SAF® Ball Race Turntables

Product Change Notice for SAF-HOLLAND Ball Race Turntables

Effective: August 2021

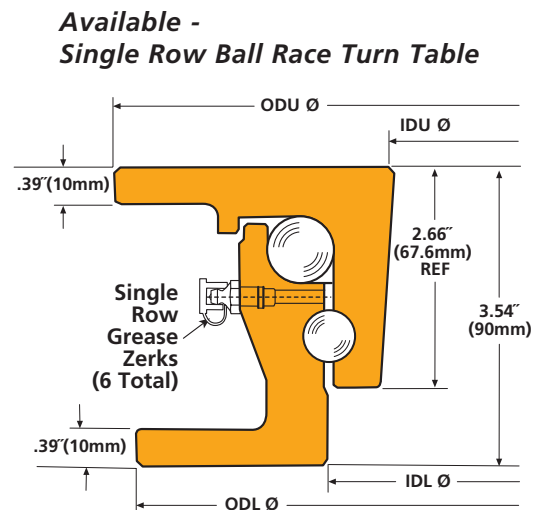
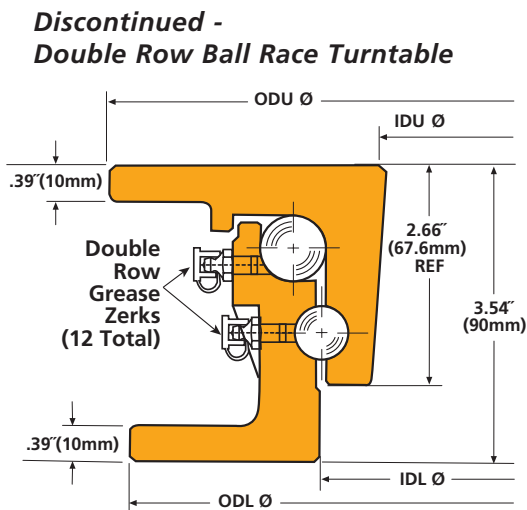
All SAF-HOLLAND ball race turntables will be equipped with a single row grease zerk pattern (6 grease zerks in total). The double row grease zerk option (12 grease zerks) is no longer available. The single row grease pattern is approved for all applications that the double row pattern was available on and will not affect the form, fit, or function of the ball race turn table. Existing orders for the double row design will be superseded and replaced by the single row design.
